389-391 STATE ST
BARRY ROBERTS -

CHECK LIST FOR SEPTIC PLANS

RE: 389-391 State Street-Request for a Local Upgrade Approval

SEPTIC SYSTEM DESIGN FOR
BARRY ROBERTS
389 - 391 STATE ST
AMHERST, MASS
ENGR: W.J. STERUTA PE
DATE: APRIL 15 2010

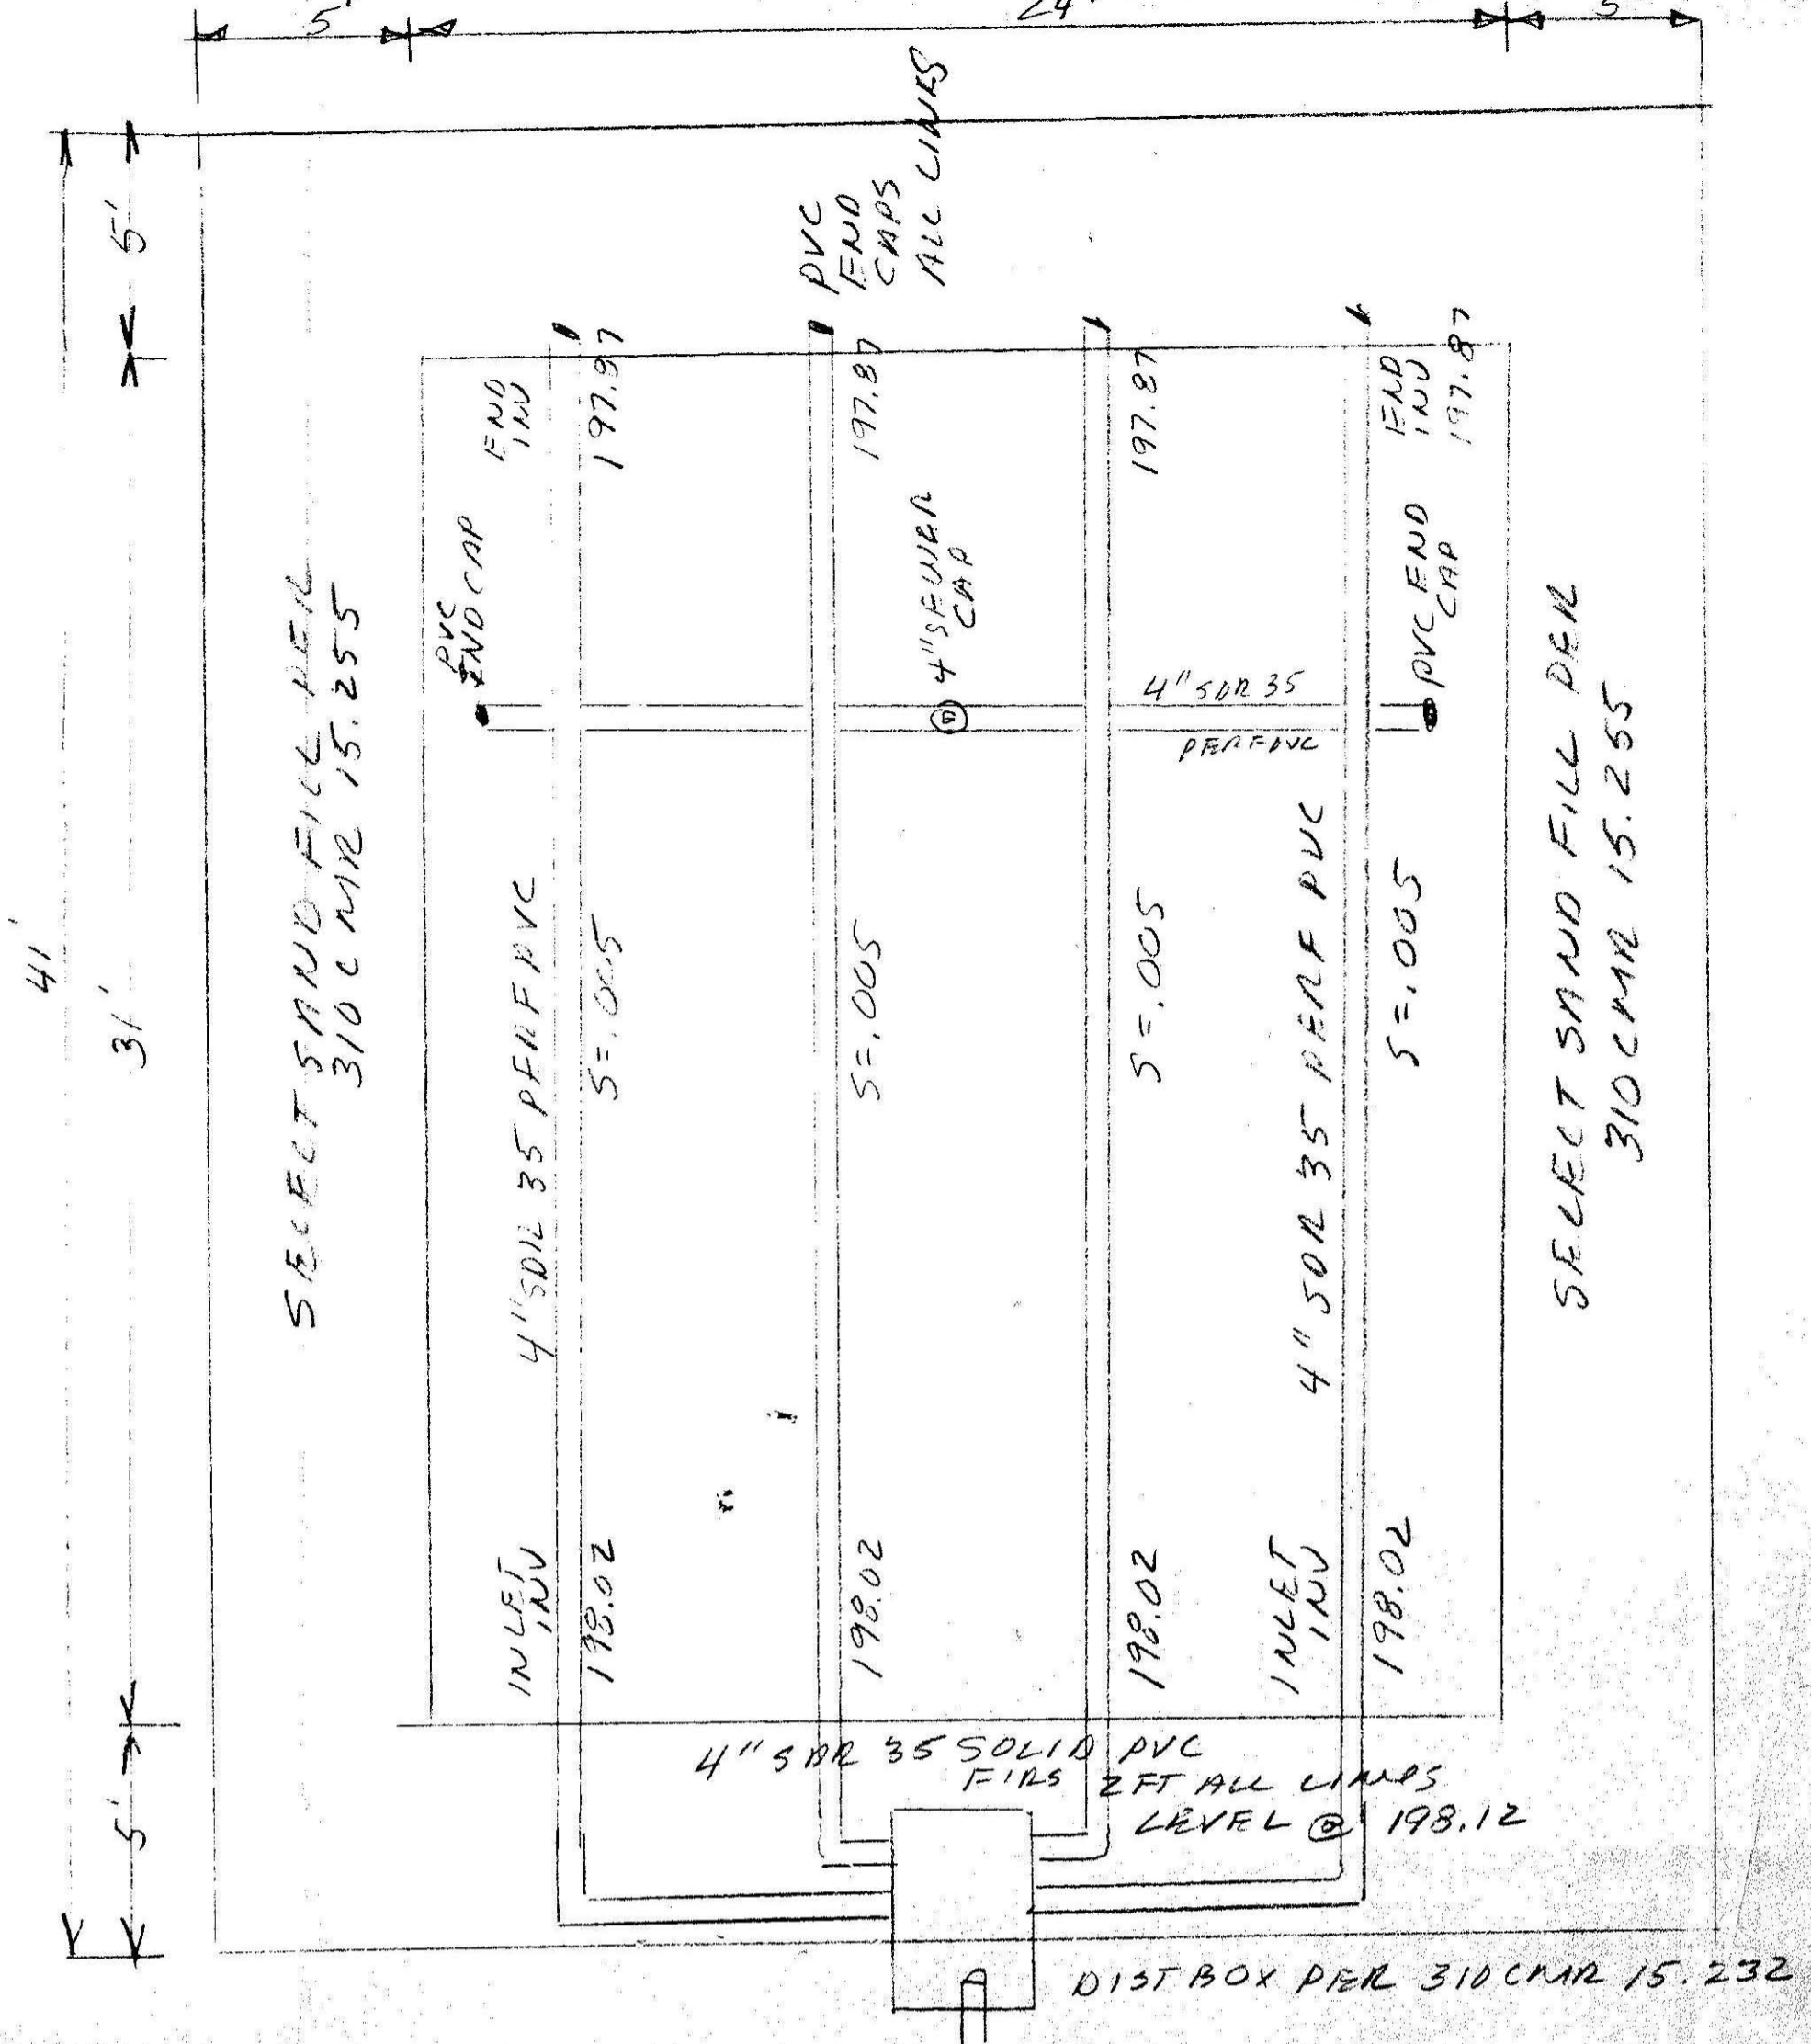
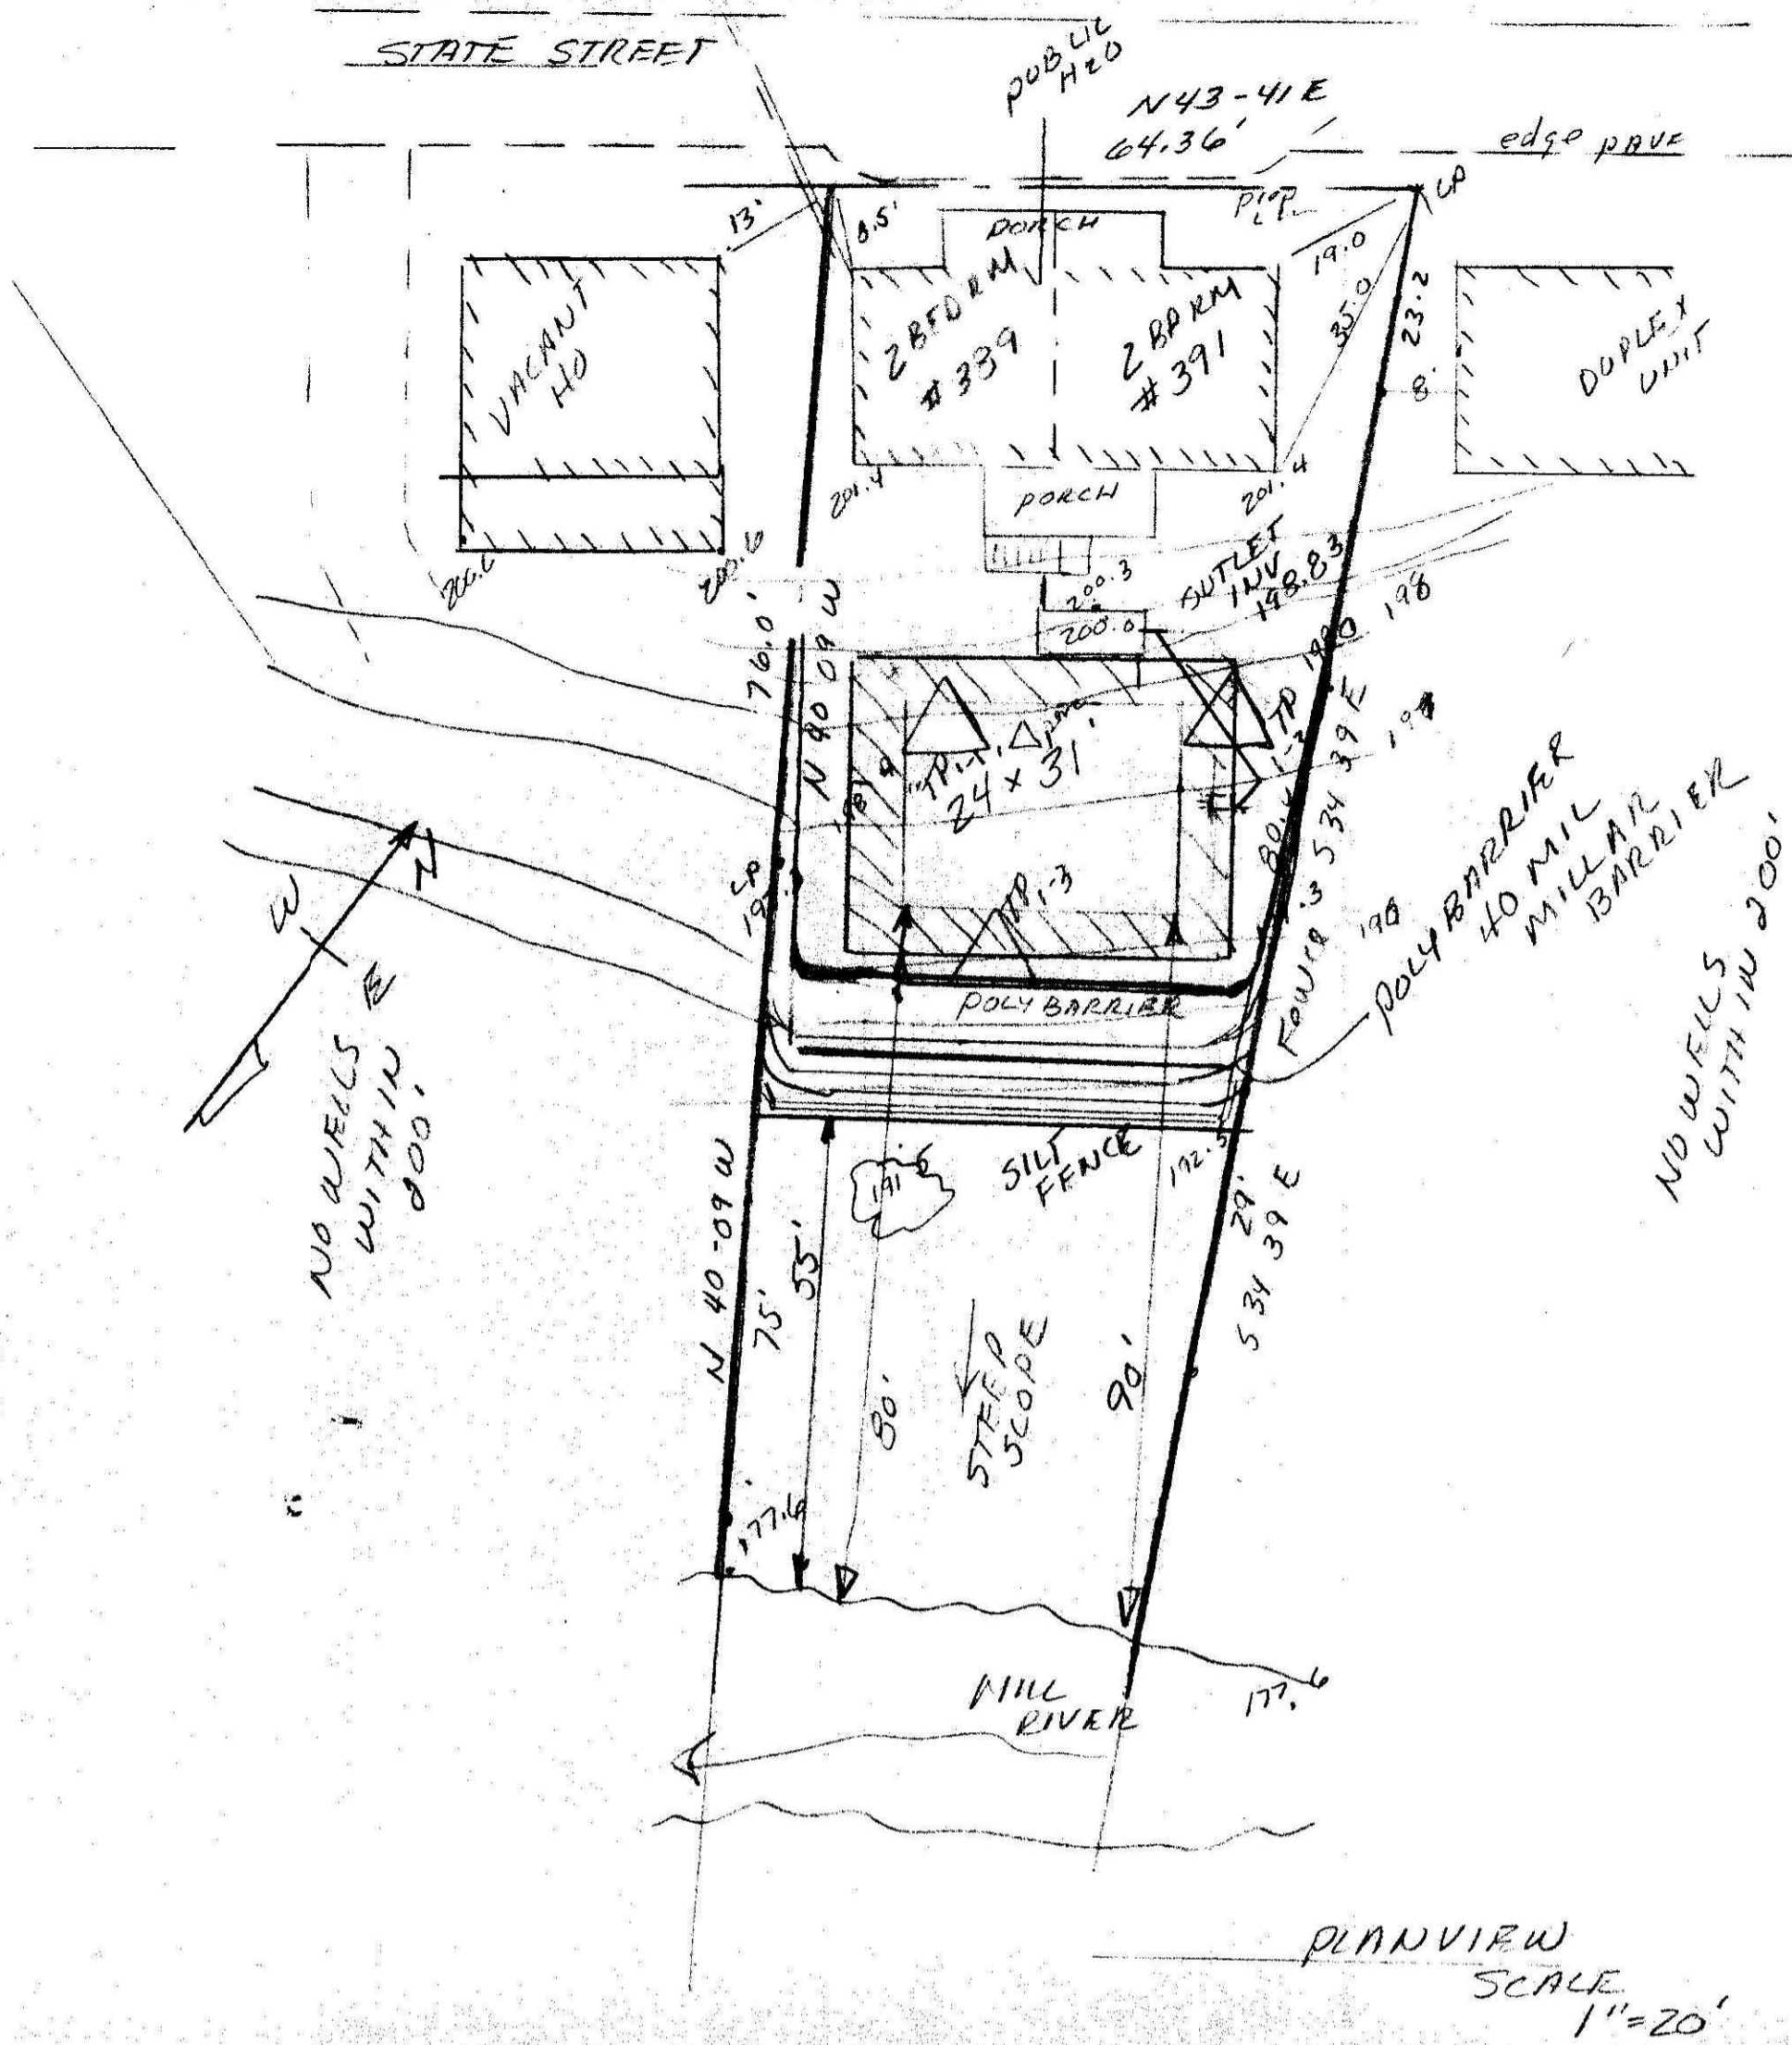
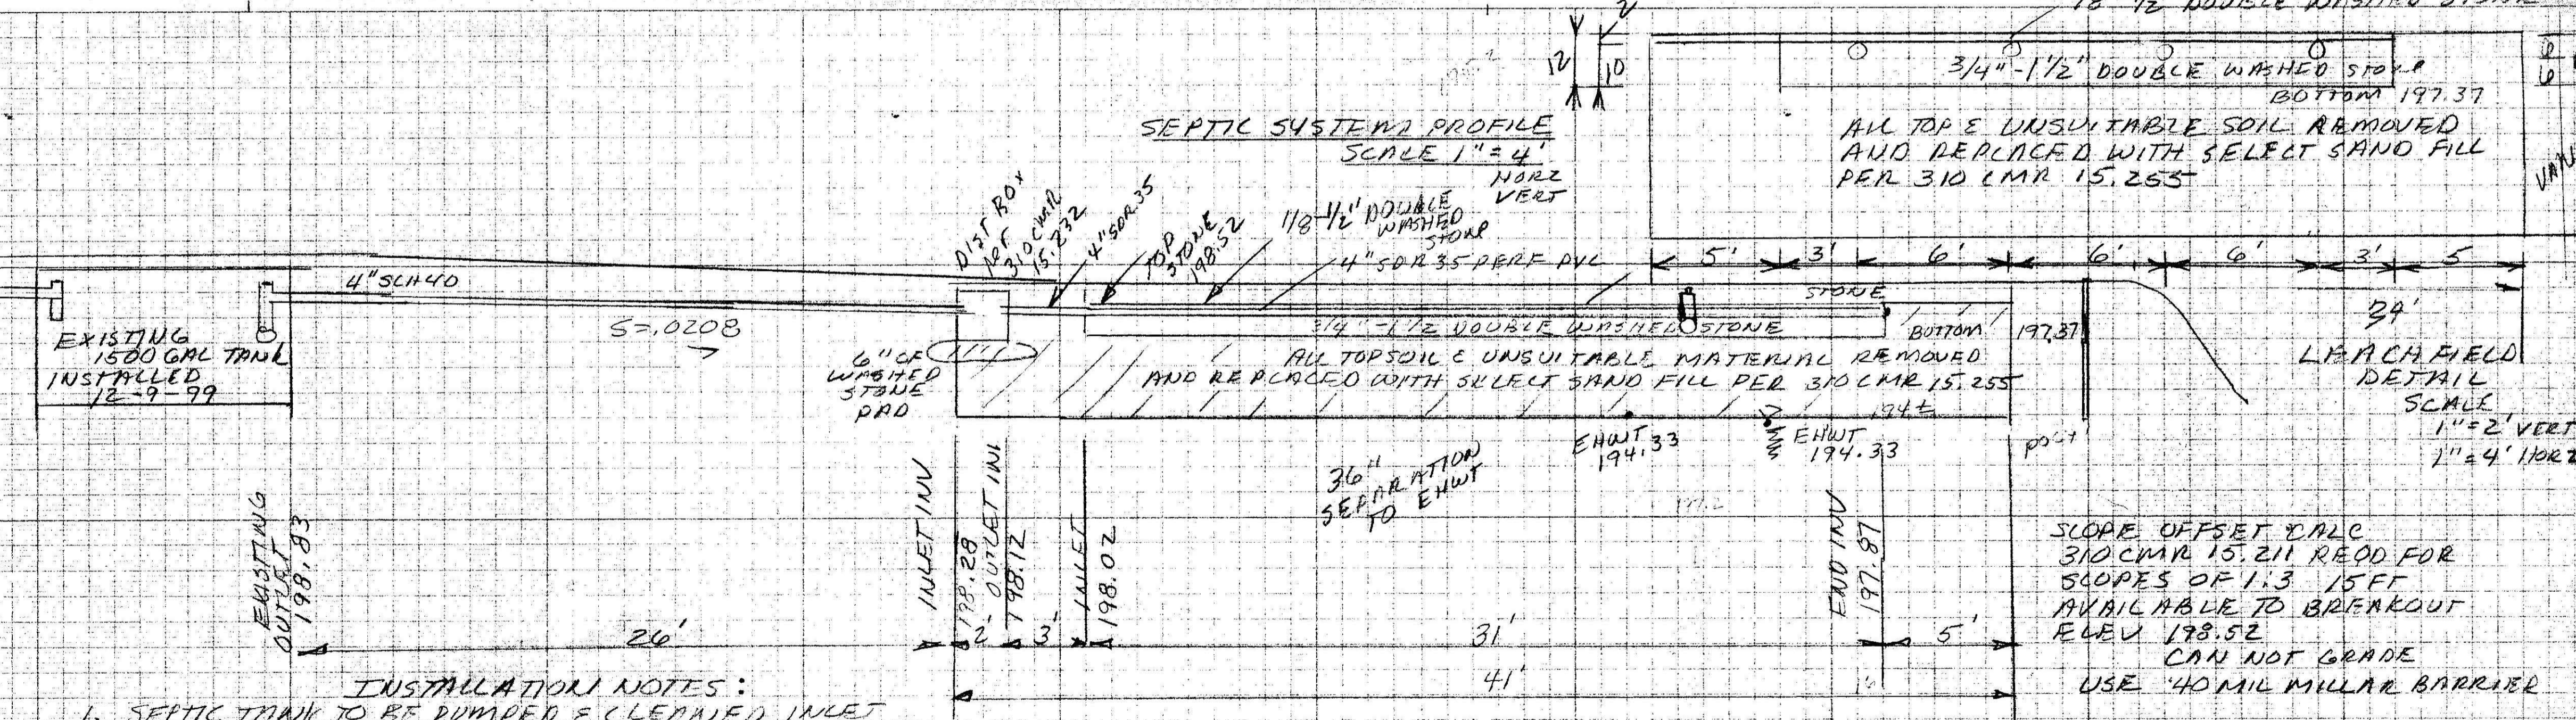
I have reviewed the plan for installation of a new sewerage disposal system at 389-391 State Street, currently owned by Barry Roberts. In my opinion the proposed septic plan design will serve to protect the public health. The current system has failed and needs to be replaced.

The Local Upgrade Approval requests a reduction from 4 to 3 feet separation between the SAS and the Estimated High Ground Water.
